SERVICE BULLETIN

No. 589B

Piper Aircraft Corporation

Vacuum System Modification

REAR VIEW OF INSTRUMENT PANEL SHOWN

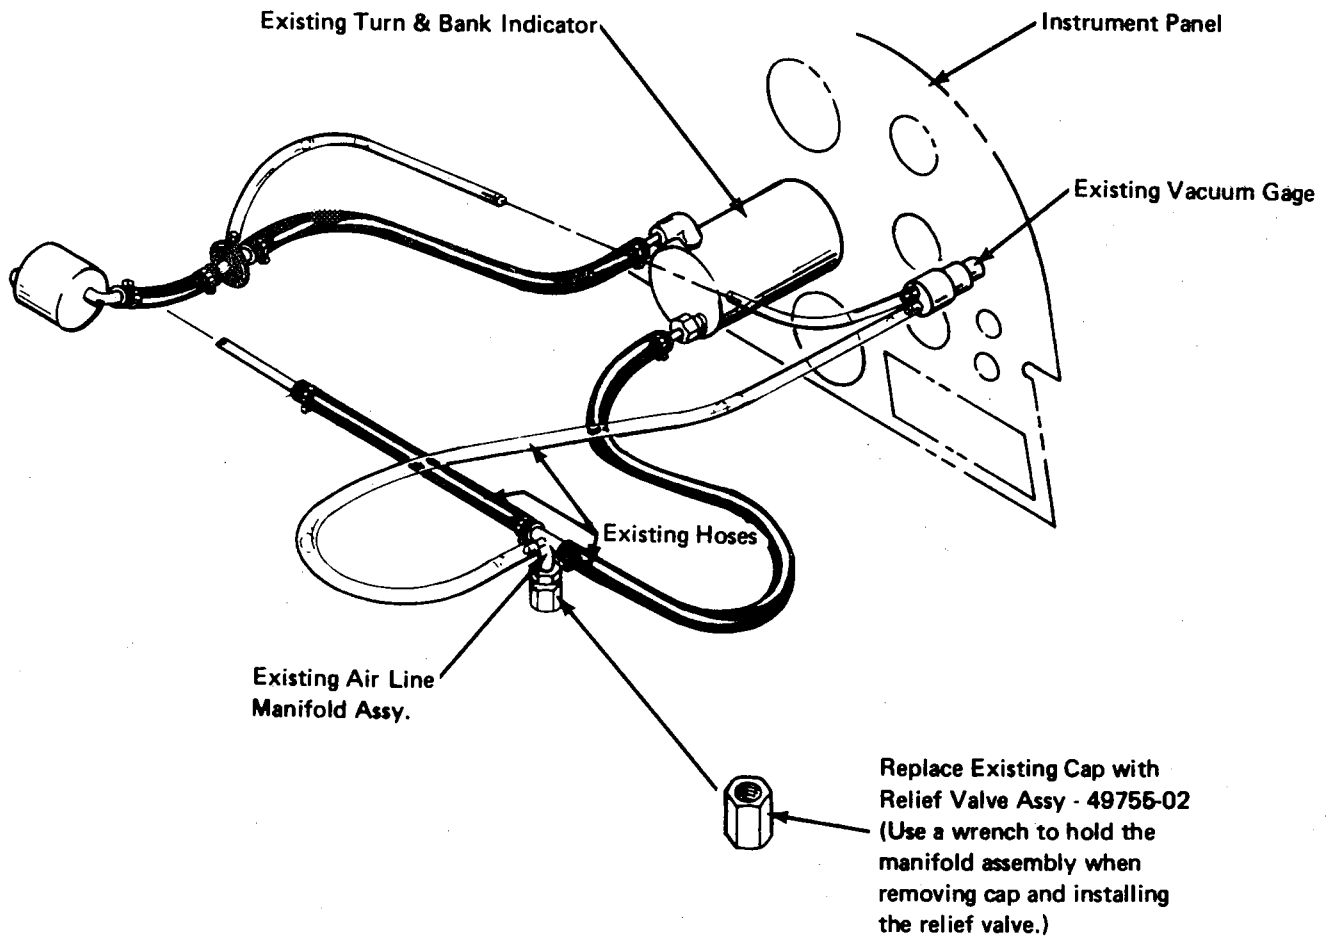
1. Locate the air line manifold assembly behind the instrument panel as shown above.
2. Remove cap from manifold assembly and install relief valve 49755-02 as shown.
(CAUTION: Use a wrench to hold the manifold assembly when removing cap and installing the relief valve.)
3. Make proper logbook entry of Service Bulletin 589A compliance.
